Shoal Creek WRF UV Replacement

ADDENDUM No. 2

Date	Friday, April 9, 2021
Bid Number	2021-WR-04
Pre-Bid Meeting	Friday, April 2, 2021 at 2:00 p.m. local time
Bid Opening	Friday, April 16, 2021 at 2:00 p.m. local time

**TYPICAL CONCRETE WALKWAY
C-32-0520**

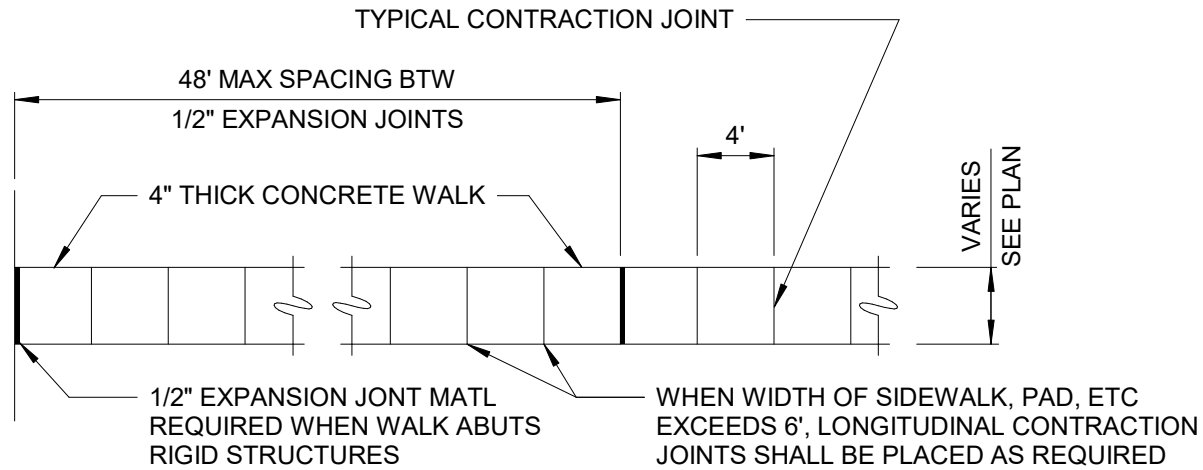
- A. Sheet SD01
 - 1. Add detail C-32-0520 See attached.

SHEET TITLE: PLAN + PROFILE STATION 0+00 - 15+00

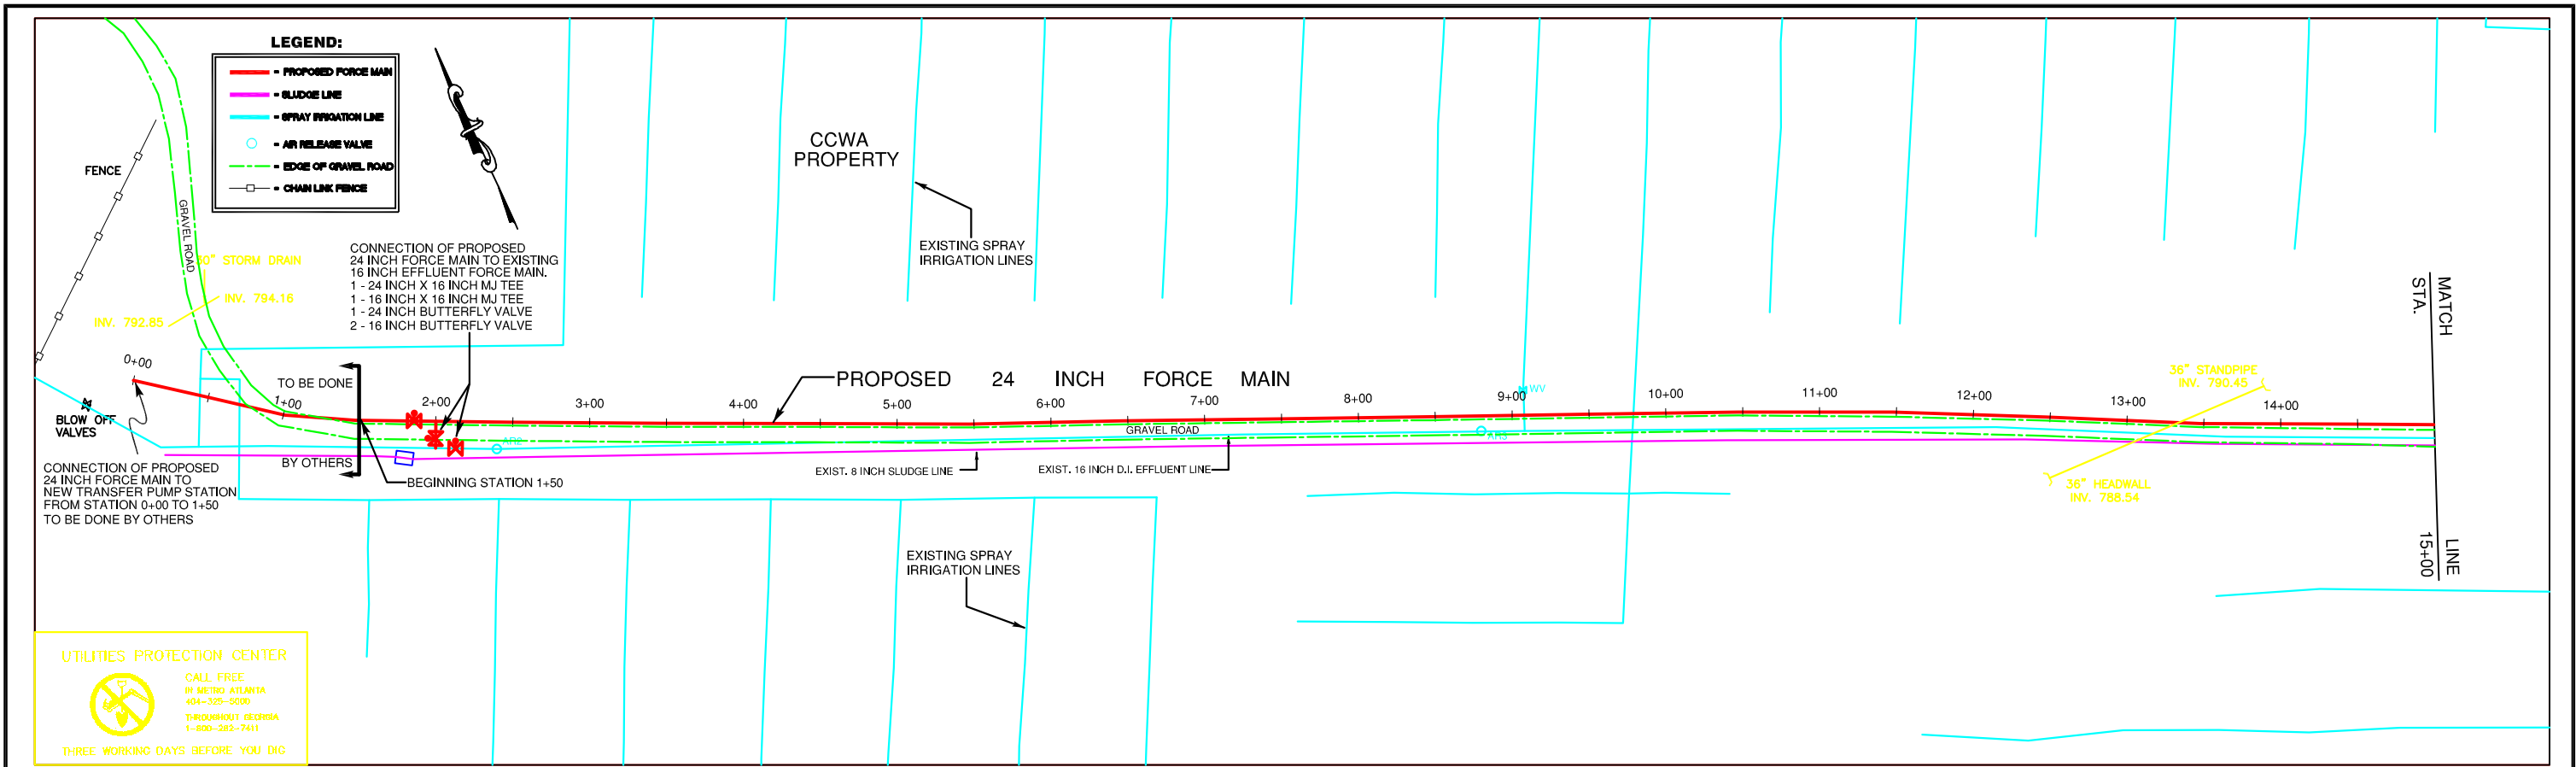
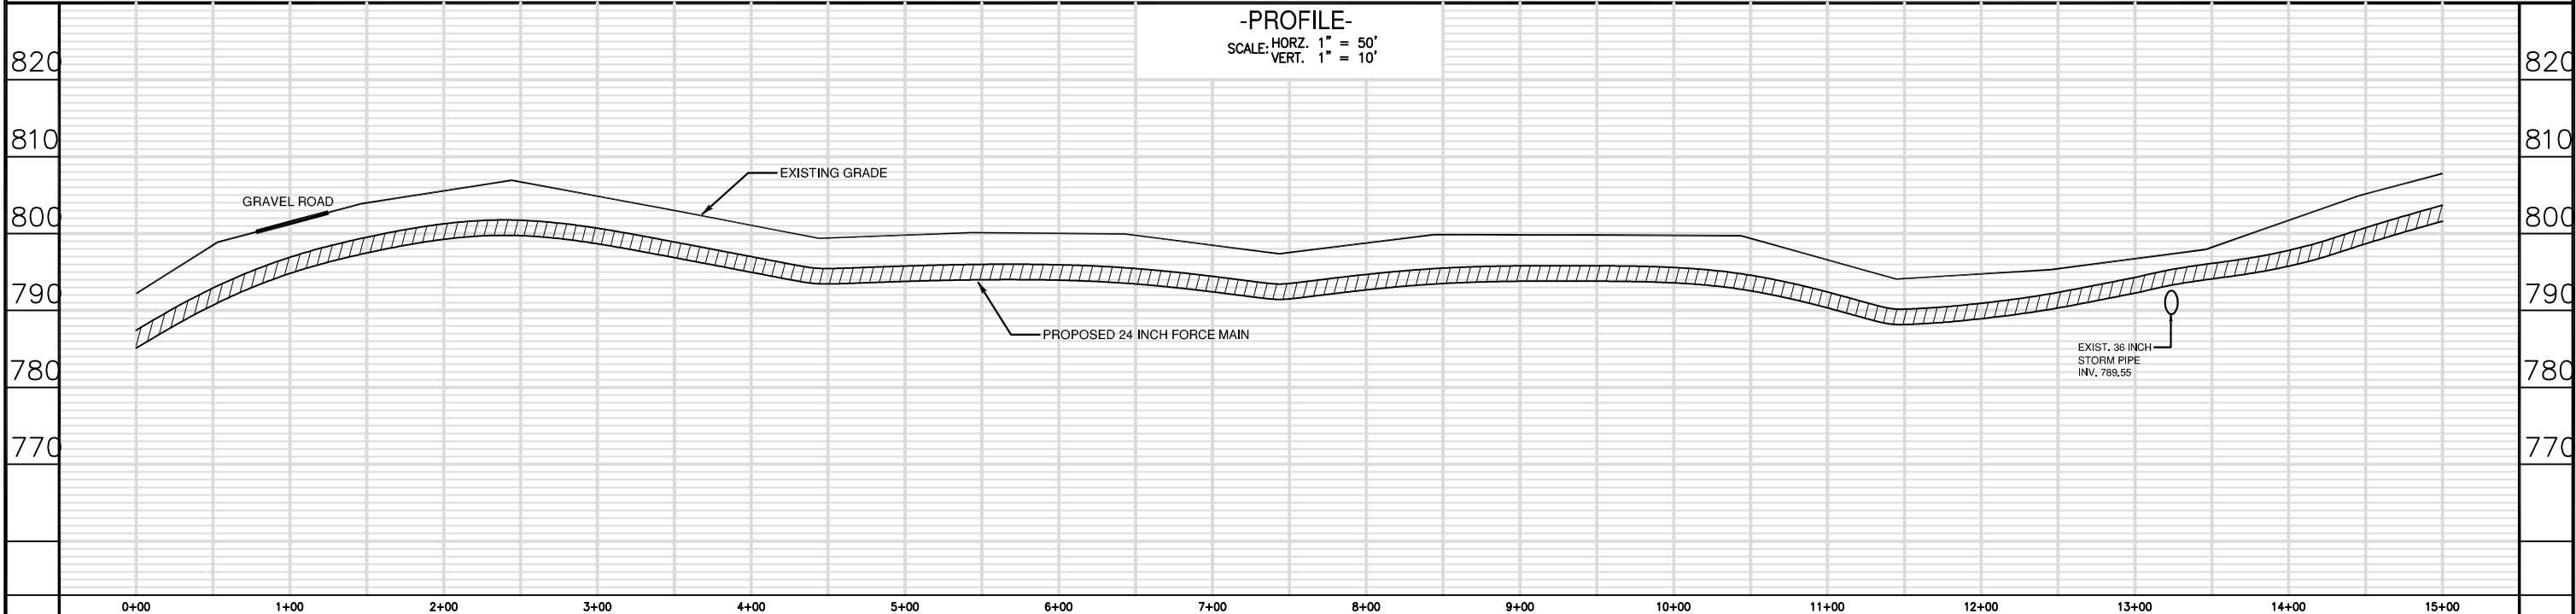
- Q14: Please provide profile information on the force main being modified.**
A14: See attached Shoal Creek WRF 24 Inch Force Main Phase One Shoal Creek WRF To Inman Road Wetland Site Sheet P-1 (CCWA, 2001).
